- 1.1 Planning application 21/00559/F was submitted to Cherwell District Council for the conversion of a garage building and erection of a single storey extension, to form a granny annexe on the 18<sup>th</sup> February 2021.
- 1.2 Oxfordshire County Council (OCC) as Local Highway Authority objected to the application on the 13<sup>th</sup> April 2021. OCC's consultation response is based upon the annexe being a new dwelling, however, it is not. The pre-application response of the Planning Officer was clear regarding the status of the proposed development:

JOB TITLE		Carters Yard		CLIENT		Mr and Mrs Bannister	
DRAWING TITLE							
Proposed Car Parking Arrangement							
Approach Visibility Splay							
SCALE	DRAWN BY	DATE	DRAWING No	REVISION			
1:200@A4	DN	May 21	23188-01

<b>Planning application:</b>	21/00559/F
<b>Location:</b>	Carters Yard Main Street Sibford Gower OX15 5RW
<b>Description:</b>	Conversion of garage building and erection of a single storey extension, to form a granny annexe
<b>Type:</b>	Full Development
<b>Case Officer:</b>	Gemma Magnuson

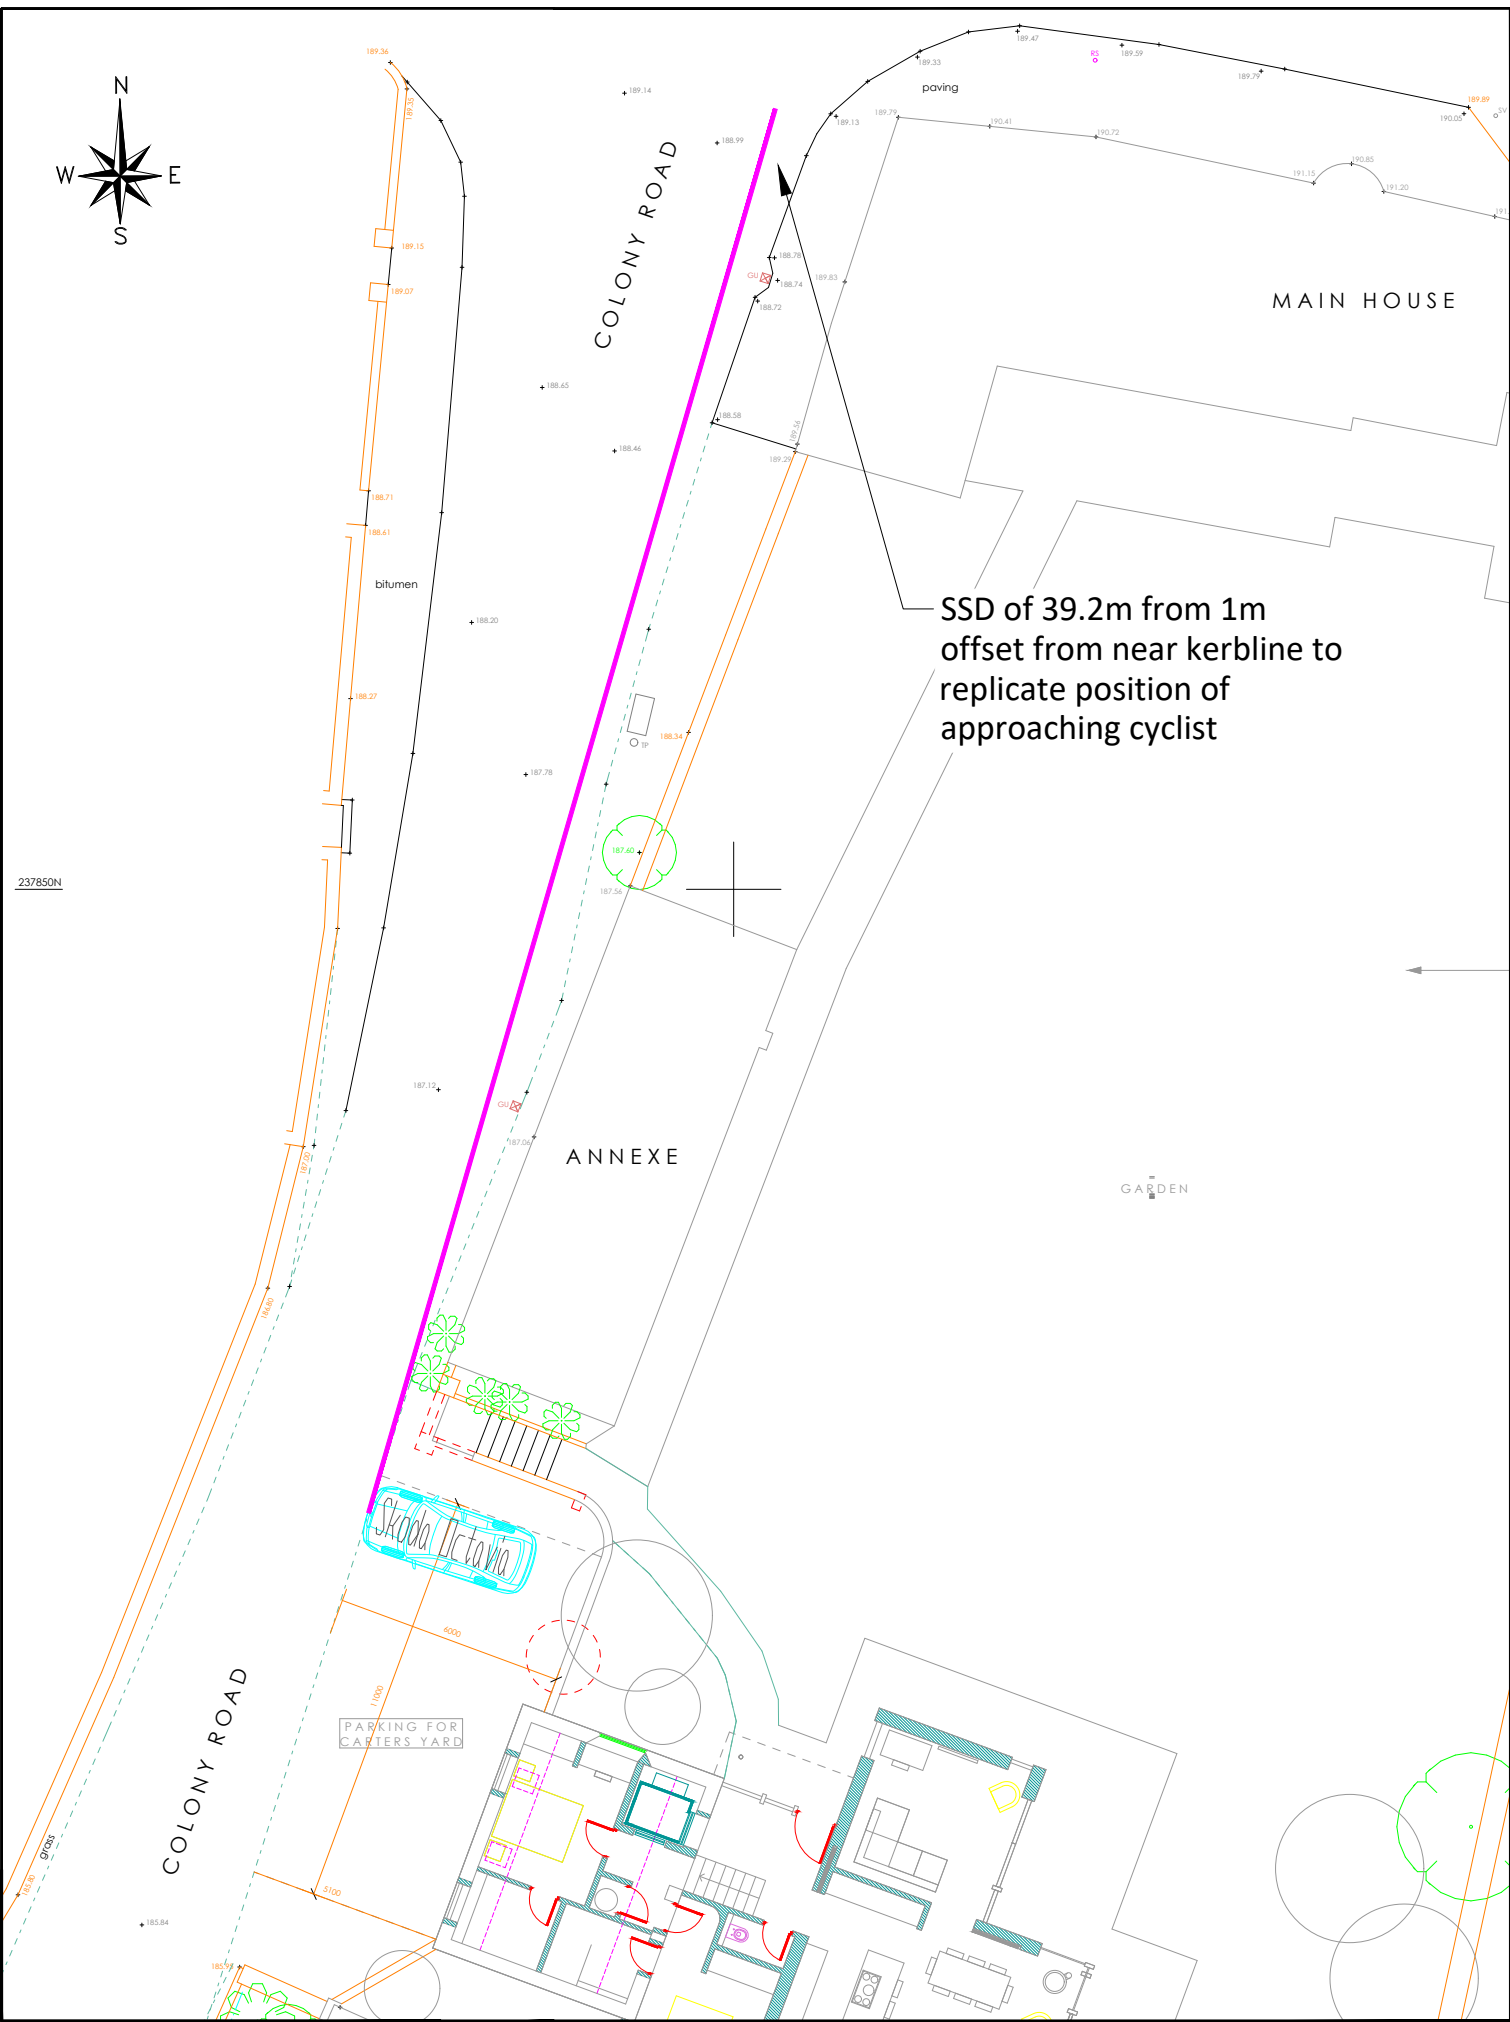
*“...However, I wish to draw the applicant’s attention to the two outer parking spaces as shown on the aforementioned drawings.*

*In order to egress from either of these spaces bounded by the sites boundary walls, this will require the bonnet of the vehicle to project out by at least a meter if not more, prior to the driver having any visibility at all of pedestrians, cyclists or other road users. This can be clearly seen from drawing 07B and the image of a car parked within this space.*

*I do accept that any such forward driving gear manoeuvre would be undertaken under extreme caution. However, for a cyclist heading downhill from Sibford towards Hook Norton, the sudden emergence of a vehicle here could result in serious injury, as no prior warning will be given, and the use of highway mirror’s is unacceptable in Oxfordshire. The same risk would also occur if this was a vehicle, as this would either require a sudden emergency stop, and the high possibility of rear end collisions, or, evasive driving manoeuvres into the path of oncoming traffic.”*

In order to egress from either of these spaces bounded by the sites boundary walls, this will require the bonnet of the vehicle to project out by at least a meter if not more, prior to the driver having any visibility at all of pedestrians, cyclists or other road users. This can be clearly seen from drawing 07B and the image of a car parked within this space.

I do accept that any such forward driving gear manoeuvre would be undertaken under extreme caution. However, for a cyclist heading downhill from Sibford towards Hook Norton, the sudden emergence of a vehicle here could result in serious injury, as no prior warning will be given, and the use of highway mirror's is unacceptable in Oxfordshire. The same risk would also occur if this was a vehicle, as this would either require a sudden emergency stop, and the high possibility of rear end collisions, or, evasive driving manoeuvres into the path of oncoming traffic.

- 2.11 The deceleration rate for traffic with speeds lower than 37mph is 0.45g which results in (d) having a value of 4.41.
- 2.12 Therefore, using the rates set out above results in an SSD of 39.2m.
- 2.13 **Drawing 23188-01** presents in magenta the required SSD/ forward visibility splay based on the above calculations at an offset of 1m to replicate the likely position of a cyclist on carriageway. An approaching driver would be further from the carriageway edge so would have improved visibility. **Image 2** below shows the streetview image from this position and it is clear that any vehicle emerging from the driveway would be seen by approaching pedestrians/ cyclists and motorists. Furthermore, the pillar at the base of the steps will be removed to improve the visibility to and from vehicles leaving the site, which will be an improvement to the existing situation.

- 2.14 Therefore, anyone approaching would have full view of the front of an emerging vehicle and be able to identify any hazard and take appropriate action safely. Of key importance, is that this is an existing driveway that has an excellent safety record with no recorded issues in at least the last 10 years as confirmed by crashmap.co.uk.
- 2.15 It can, therefore, be concluded that the proposed alterations to the existing parking arrangements would not result in an unsafe arrangement or in anyway be detrimental to highway safety.

SSD of 39.2m from 1m offset from near kerbline to replicate position of approaching cyclist
